Riley Drive Wastewater Lift Station

PW 20-058

### **Addendum No. 2**

**ATTACHMENT 3  
TO ADDENDUM NO. 2  
PUMP PERFORMANCE CURVE**

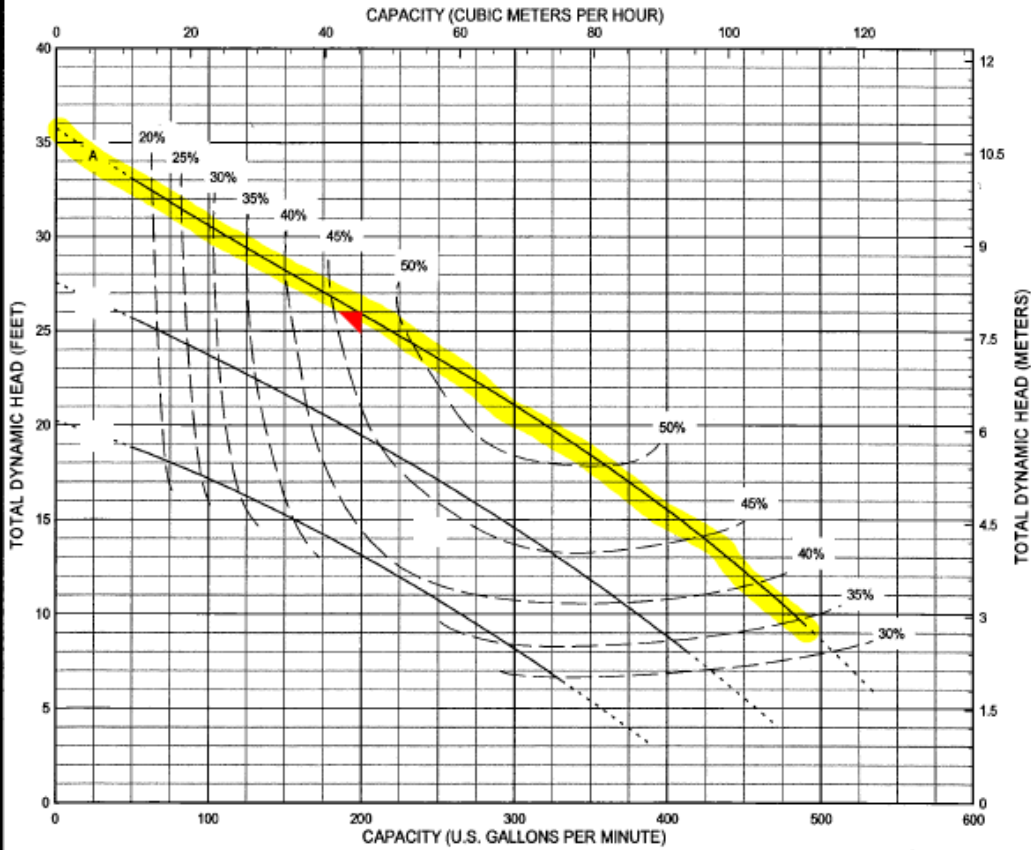
Answer For the Vaughan Chopper pump specified on Page 50 of the IFB, Sheet M1, the City of Avondale will accept an “approved-equal” pump to match the mechanical and performance specifications of the 5 HP Vaughan Submersible Chopper Pump – Model No. SE3F-060, rated for 200 gpm at 26ft TDH. The performance pump curve of “approved-equal” pump must match the attached performance curve of the specified Vaughan pump for total dynamic head and efficiency for the flow rates along the curve at 50gpm, 200 gpm, and 400 gpm. (See attachment 3 Pump Performance Curve)
